Project	IEEE 802.16 Broadband Wireless Access Working Group < http://ieee802.org/16 >	
Title	DL and UL loading parameters information	
Date Submitted	2007-02-15	
Source(s)	Peretz Feder – Alcatel-Lucent Phillip Barber - Huawei Honghai Zhang – Alcatel-Lucent	pfeder@alcatel-lucent.com pbarber@broadbandmobiletech.com hozhang@alcatel-lucent.com
Re:	IEEE 802.16 Session #47 plus over the phone	
Abstract	This contribution proposes the updates of IEEE 802.16g D7 document in order to obtain loading information from the Base Station	
Purpose	Update 802.16g draft obtain uplink and downlink loading information	
Notice	This document has been prepared to assist IEEE 802.16. It is offered as a basis for discussion and is not binding on the contributing individual(s) or organization(s). The material in this document is subject to change in form and content after further study. The contributor(s) reserve(s) the right to add, amend or withdraw material contained herein.

DL and UL loading parameters information

Figure - 57 Maintaining downlink synchronization

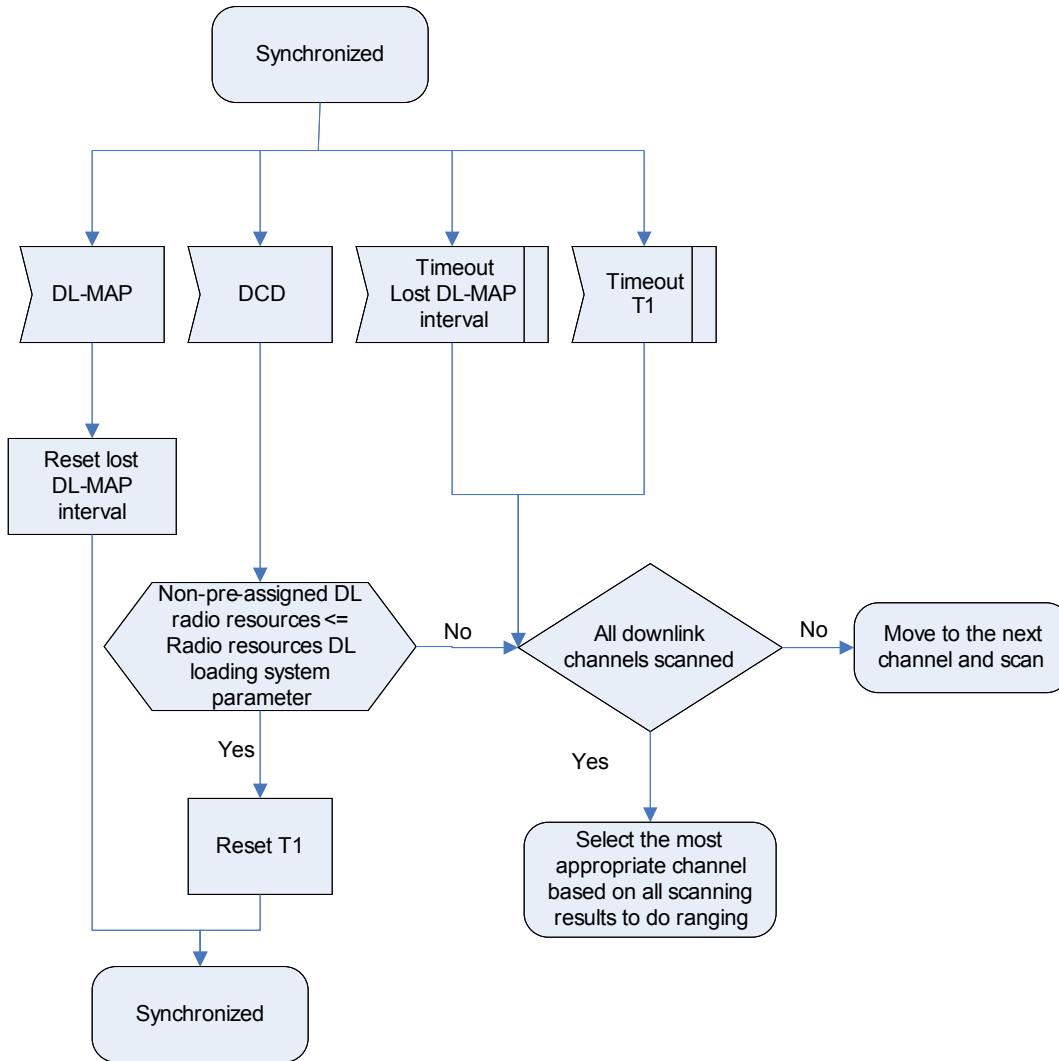
The MAC shall search for the DL-MAP MAC management messages. The SS achieves MAC synchronization once it has received at least one DL-MAP message and is able to decode the DL-Burst Profiles contained therein. An SS MAC remains in synchronization as long as it continues to successfully receive the DL-MAP and DCD messages for its Channel **and the Non-pre-assigned DL radio resources in the DCD message are higher than the Radio_resources DL loading_system_paramater**". If the reported Non-pre-assigned DL radio resources are less than the "Radio_resources DL loading_system_paramater" threshold the SS/MS should continue scanning to find another channel until all channels are scanned. If all channels are scanned, the MS will choose the most appropriate channel to perform initial ranging according to section 6.3.9.5 based on the CINR and the available Non-pre-assigned DL/UL radio resources of all channels. If the Lost DL-MAP Interval (Table 342) has elapsed without a valid DL-MAP message or the T1 interval (Table 342) has elapsed without a valid DCD message, an SS shall try to reestablish synchronization. The process of acquiring synchronization is illustrated in Figure 56. The process of maintaining synchronization is illustrated in Figure 57.

(Note to Editor: Need to modify Figure 57)

Figure 59 – Maintain uplink parameters

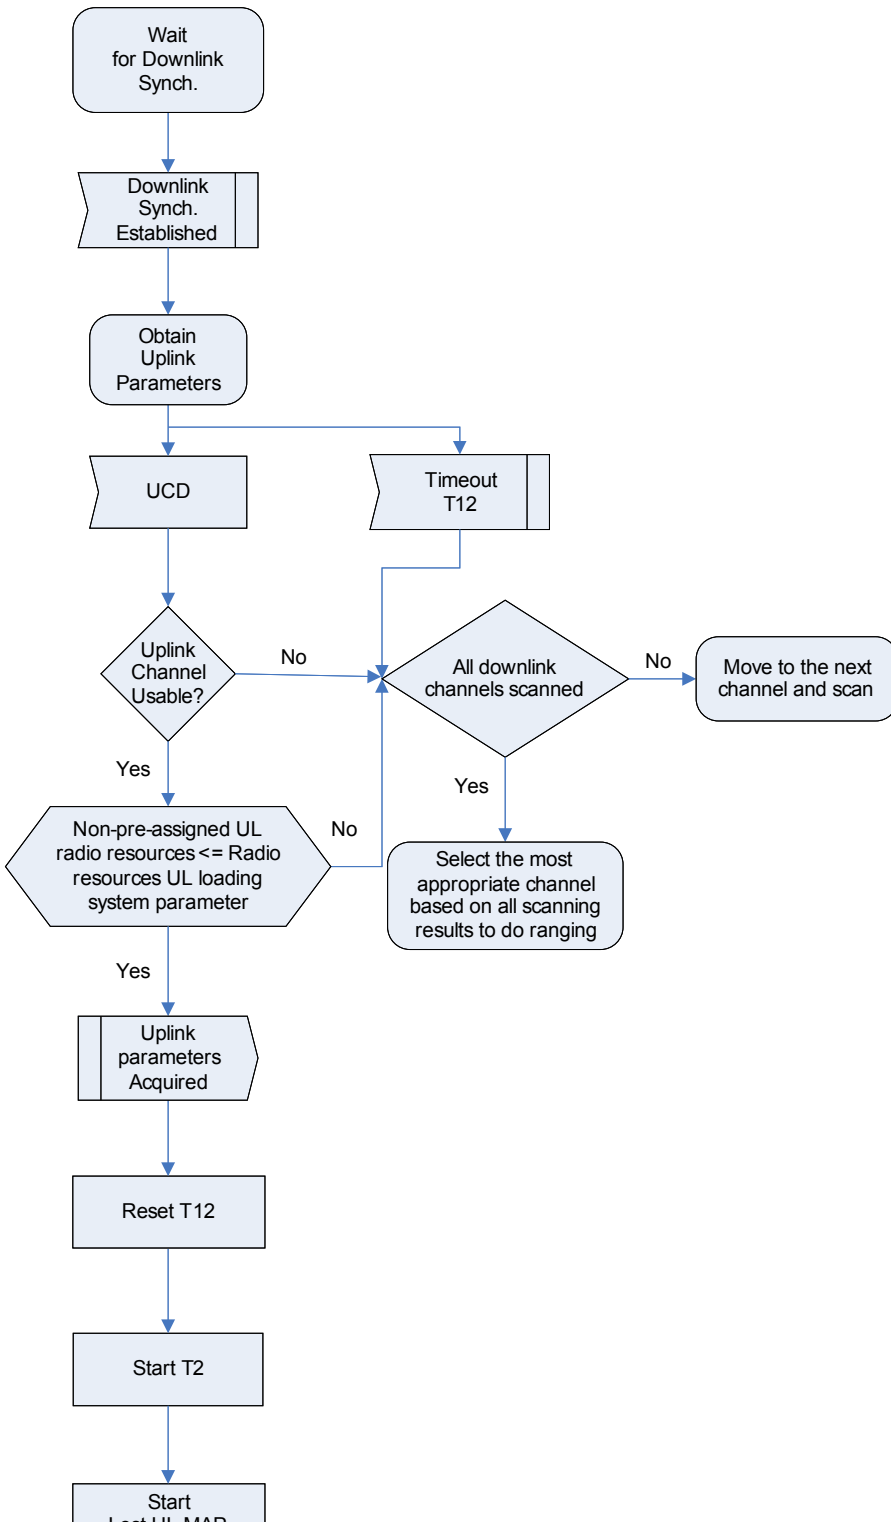
The SS MAC is considered to have valid uplink parameters as long as it continues to successfully receive the UL-MAP and UCD messages. If at least one of the messages is not received within the time intervals specified in Table 342 or the Non-pre-assigned UL radio resources are lower that the Radio_resource_UL_loading_system_parameter, the SS shall not use the uplink. This is illustrated in Figure 59.

(Editor: need to change Figure 59)
